Design Review Subcommittee (DRSC)

Meeting Date: November 14, 2016

SUBJECT: Cultural Heritage Permit 16-376/Conditional Use Permit 16-337/Minor Site Plan Permit 16-378, Miramar Events Center, a request to:

Proposed Architecture

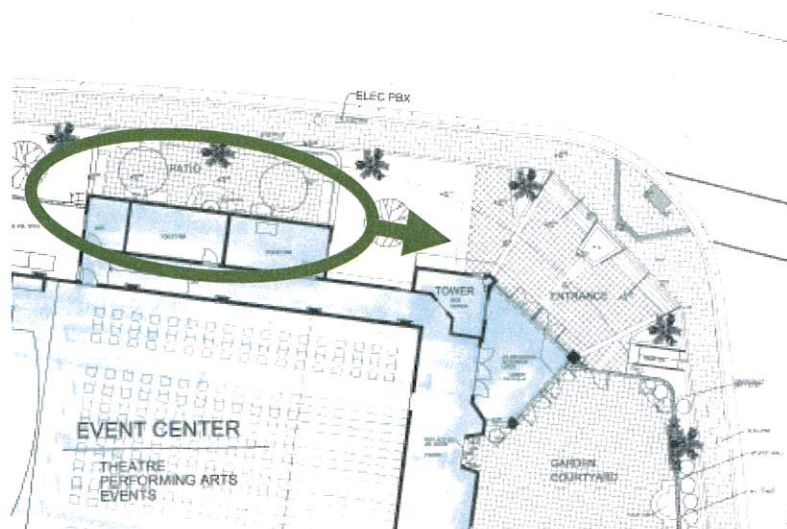
The proposed architecture for the additions to the site is characteristic of a Spanish Colonial Revival style. The outdoor plaza space proposed is a traditional element of Spanish Colonial Revival design and is encouraged in the design guidelines. Staff is comfortable that overall the project complies with the Design Guidelines, Urban Design Element of the General Plan and the CHP findings summarized above. However, there are some aspects related to the project design that can be improved, and if incorporated strengthen the projects compliance with the General Plan goals and City Design Guidelines. The following discussion focuses on the characteristics of the building elevations and site design that can improve the overall compliance with the City's General Plan.

Miramar West/El Camino Real Elevation

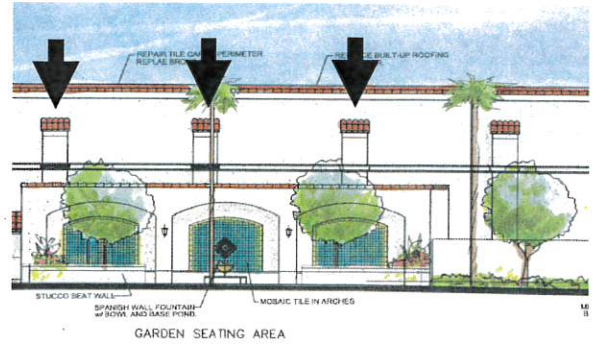
1. Staff suggests that the addition alongside the theater (Orange Julius) be redesigned to align the arches between the buttresses on the Miramar.
2. Consider a simple Ole Hanson paver cap for the cornice rather than barrel tiles.
3. Consider using full arches as opposed to segment arches, segmented arches should be used sparingly. The proposed design is too contemporary in style, if used they should be designed consistent with the example provided here from the Henry Lenny Design guidelines.

4. The mosaic tiles inside the arches should be a traditional decorative tile.
5. With the relocation of the patio suggested above, remove the fountain, and consider a wall fountain in the middle arch if there ends up being an odd number of arches in the redesign. If there is an even number of arches, then staff recommends not including a wall fountain.

Bowling Alley West/El Camino Real Elevation

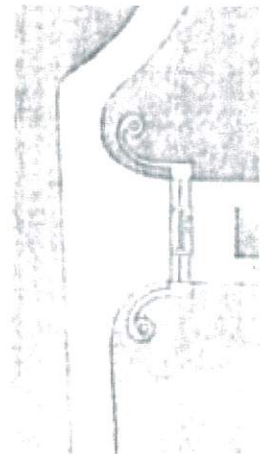
1. For the addition change the two segmented arches to full arches or consider alternative style opening.
2. The small tower on the façade at the entrance to the bowling alley is very simple. To improve compatibility consider simplifying the tower element on the addition. A single inset vent would work better.

3. The arch entry to the courtyard patio has a contemporary style. In addition the walls around the outdoor patio make the space less inviting to pedestrians walking along the sidewalk. A more open inviting and less contemporary looking (as shown in the photo to the left) opening leading to the patio will make the entry from the sidewalk more inviting. This could be accomplished with curved walls as shown in the original site plan design for the Beach Club. Also the walls should provide more openings and be as low as possible to provide more visibility along El Camino Real.

4. Staff recommends removing the wood trellis element from the walls. The walls should be simplified, there is too much variation in style. It would be better to have a consistent and traditional design theme with stucco walls, wrought iron fence and regularly placed columns.

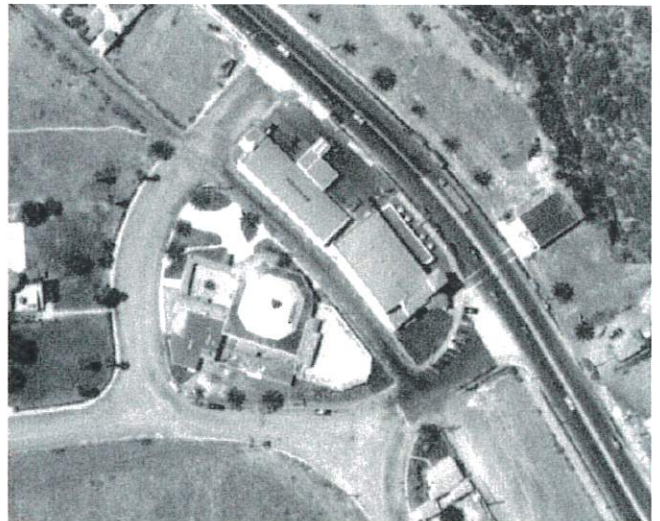
defining feature of the theater. The proposed 5-6 foot high wall around the Garden Courtyard area blocks a portion of the public view of the building. Staff is recommending that a wrought iron fence replace most of the wall to allow views of into the site. The portion of the wall along Dischecha should be retained to help buffer the residential areas located to the southeast of the site.

- 2. The applicant proposes to enclose the front entrance area with wood and glass doors to provide more usable area for the lobby. Staff is supportive of this concept so long as the doors and windows are installed in a way that does not impact this historic fabric and is reversible should a there be the desire to open the area back up at some future date.

- 3. The applicant should consider including some of the exterior painted details on the theater. If the original design and paint color maybe discovered as part of the restoration of the building.

- 4. The proposed redesign of the bowling alley west elevation shown below removes the historic stairway leading to the bowling alley entrance from the sidewalk and replaces it with a ramp and walls. This changes the context of the original entrance to the bowling alley and should be redesigned to preserve the stairway. An example of a more appropriate treatment is included as a design option in the Historic Structures Report, shown in the rendering below.
